Project: IEEE P802.15 Working Group for Wireless Personal Area Networks (WPANs)

Submission Title: [Resolutions for new comments received after May 5 before May 9]

Abstract: [Resolutions for new comments received after May 5 and May 9 are shown.]

Resolutions for the new comments received before May 9

Figure 189

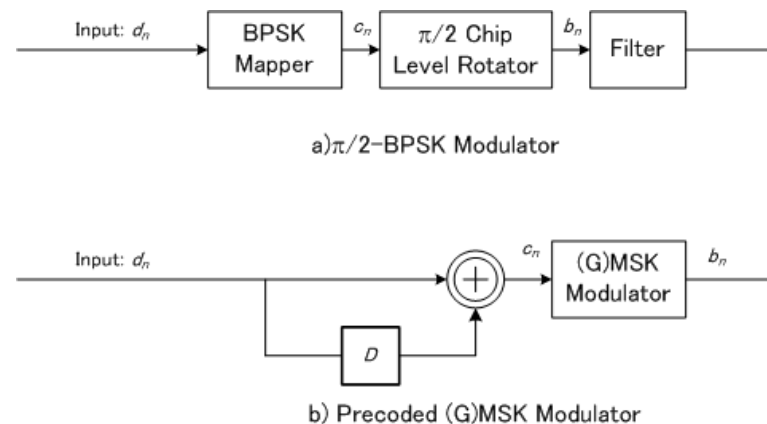
- Figure 189, more description in terms of equations is required to equate $\pi/2$ BPSK modulator and GMSK modulator. For example initial phase of the chip level rotator. Also, the differential operation (xor) as currently specified is incorrect. If g_n is the input to the GMSK modulator then in the real field $g_n = d_n \times d_{(n-1)}$ which is inverse of xor. In general, complete specification through equations would help rule out ambiguity
- Resolution: Accept the comment partially. Equations shown in the next slide shall be added to equate $\pi/2$ BPSK modulator and GMSK modulator. Figure 189 shall be replaced as shown in the next slide.

To be modified
